CITY OF OREGON CITY HISTORIC REVIEW BOARD AGENDA

Staff Report

GLUA-24-00007: HR 24-00006 Historic Review - New Construction of a dwelling unit in conjunction with an existing office use (G.R.H. MILLER HOUSE) in the McLoughlin Conservation District- 406 Promenade

REQUEST: Historic Review for solar panel installation of street-facing roof planes on a non-contributing designated structure in the Canemah Historic District

Figure 5- Elevations

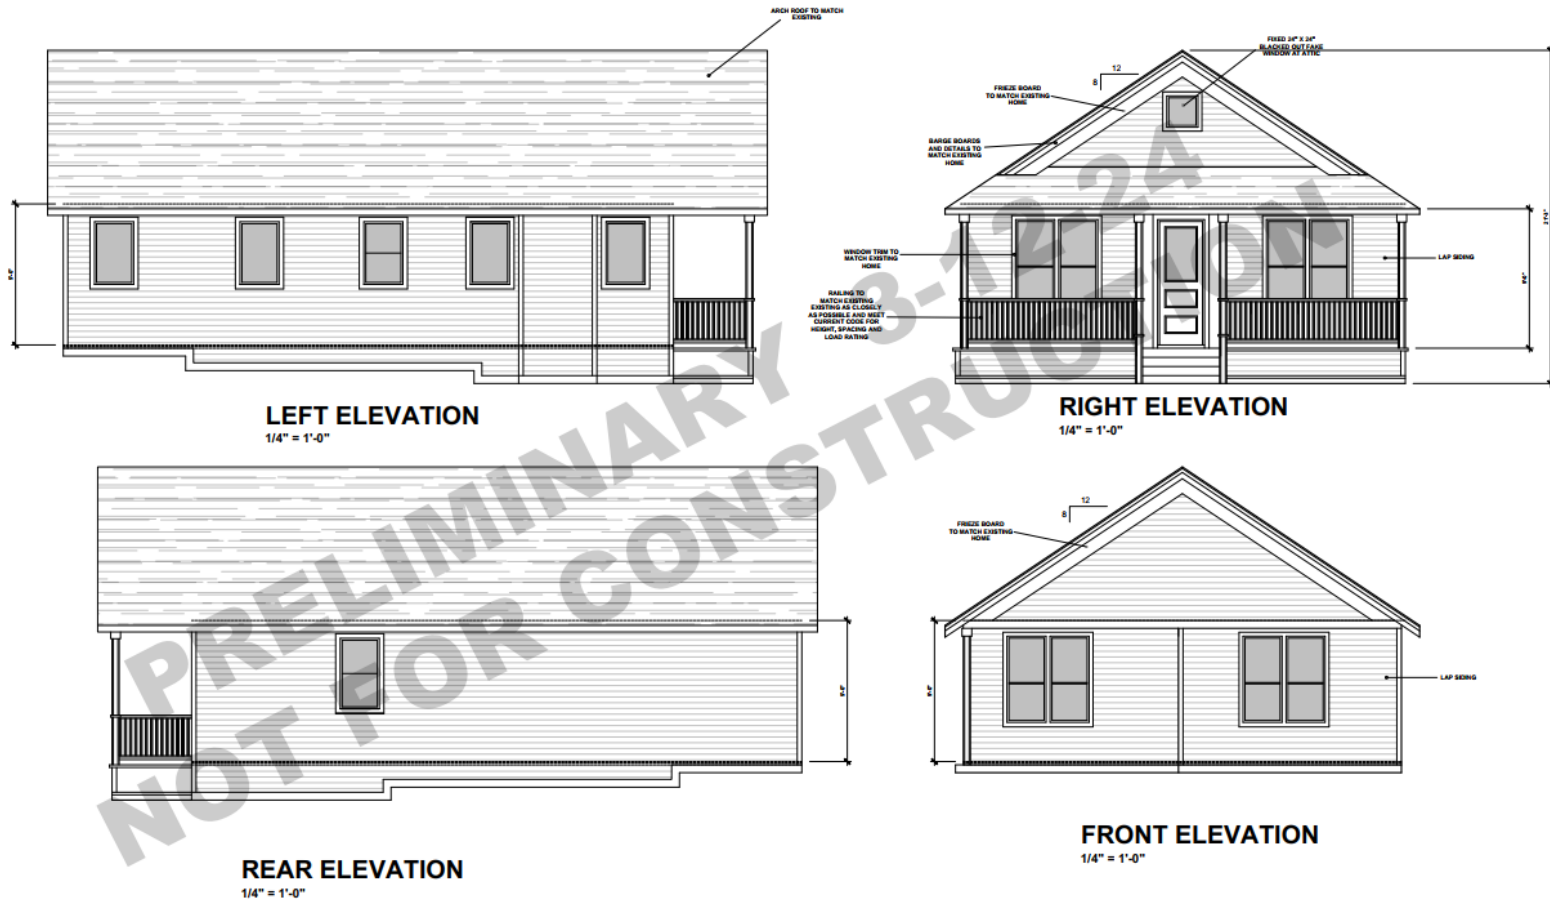
Staff recommends that the Historic Review Board discuss the approach to the front porch design with the applicant and determines if an additional condition needs to be added to express the desired porch details. The side and front elevations of the submitted plans are confusing to read, and this issue can potentially be rectified by the applicant submitting a 3D rendering of the front of the house. Two standard approaches to bungalow porches would be a porch design, which is an extension of the gable eaves connected to the porch posts, or a separate hipped or gabled roof porch extending past the gable roof's eaves.

9. The applicant shall ensure that the submitted elevations for the Building Permit match the correct locations (front-side-rear -etc) and orient the front elevation to High Street. This revision will provide clarity through the Conditions of Approval review and the Building Permit process.

Staff recommends that the Historic Review Board discusses the approach to the front porch design with the applicant and determine if an additional condition needs to be added to express the desired porch details. The side and front elevations of the submitted plans are confusing to read, and this issue can potentially be rectified by the applicant submitting a 3D rendering of the front of the house.

Figure 6: Site Plan

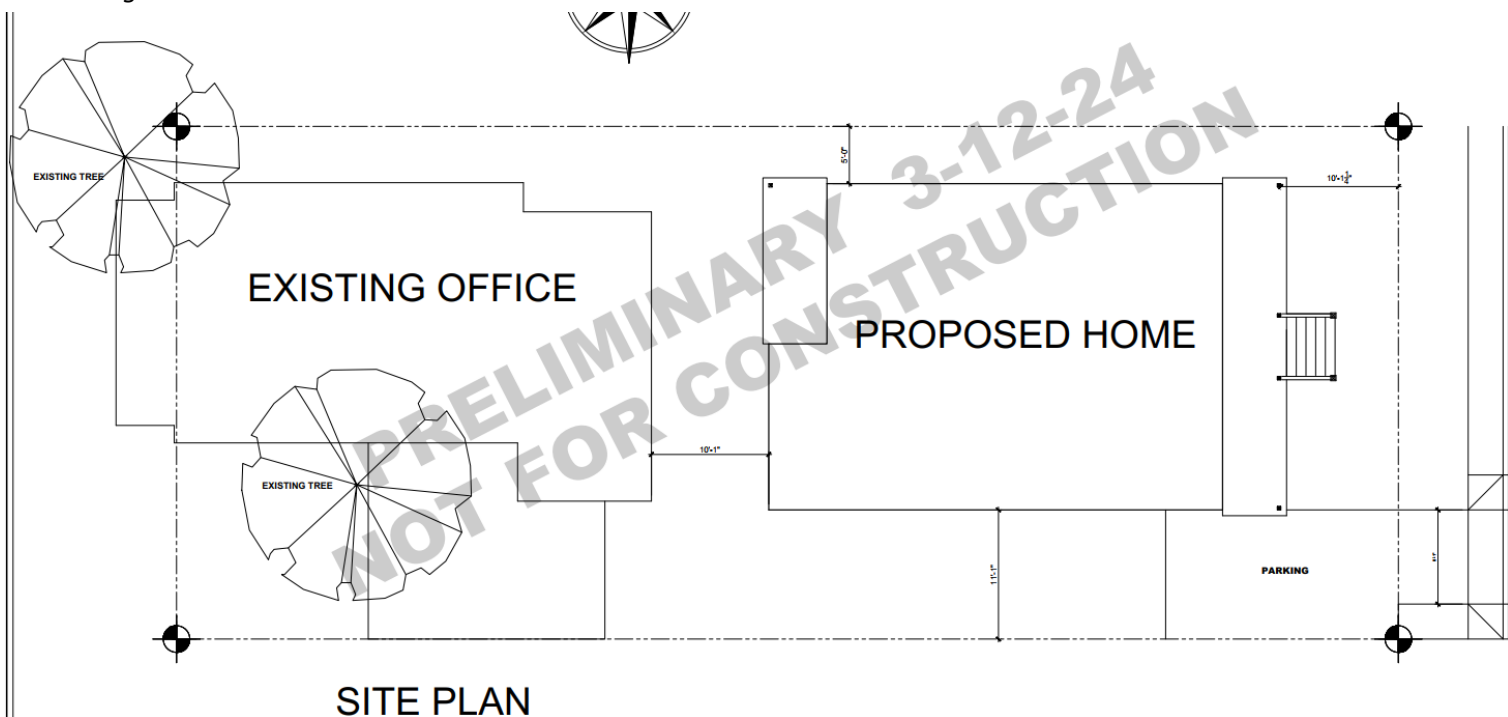
6. The applicant must use French doors. Slider doors are not allowed.
7. The applicant has proposed a 10-foot setback from the front of the porch to High Street. During the Building Permit plan review, the applicant may choose to place the building up to five feet closer to the street without returning to the Board for approval. However, the setback between the new construction and the G.R.H. MILLER HOUSE on the same lot shall be at least 10 feet.

The applicant has indicated that they will look to provide a small parking space next to the new dwelling unit utilizing a small one-car driveway. This is not shown on the site plan and is permitted through development services as part of the building permit process, which is an acceptable approach for this area.

Proposed Roof plan

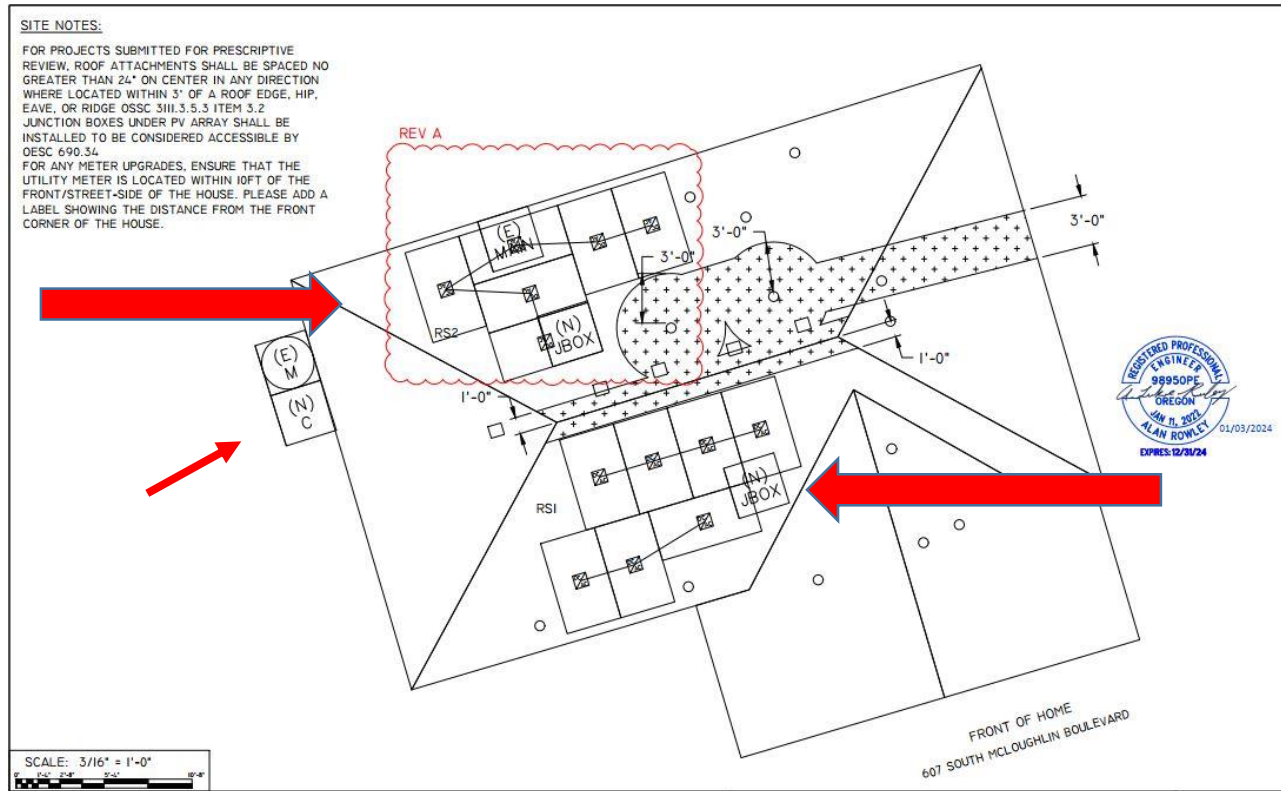
Pursuant to Historic Review Board Policy #12: *Solar Technology*, solar panels on sloped roof locations like the subject property, “*are permitted on secondary facades of historic buildings and on accessory structures.*” Six of the thirteen proposed solar panels appear to meet applicable standards, being shown on a secondary, rear-facing roof plane. However, seven of the thirteen panels are proposed to be located on the primary, street-facing roof plane due to its direct southern exposure and higher solar irradiance than all other secondary roof planes.

The Board may want to consider a condition of approval to require an alternatives analysis for locating the front-facing panels on the western, left-facing roof planes. The Board may also want to consider a condition of approval for the applicant to demonstrate the viability of the solar panel project on a cost/benefit basis for keeping the proposed configuration vs. other alternatives.

Staff is requesting confirmation from the Historic Review Board that these are significant mitigating factors to allow street visible solar panel placement. If the Board finds that these panels will impact the historic integrity of the home, the proposal’s impacts may be mitigated by limiting the number of panels on the upper roof plane.
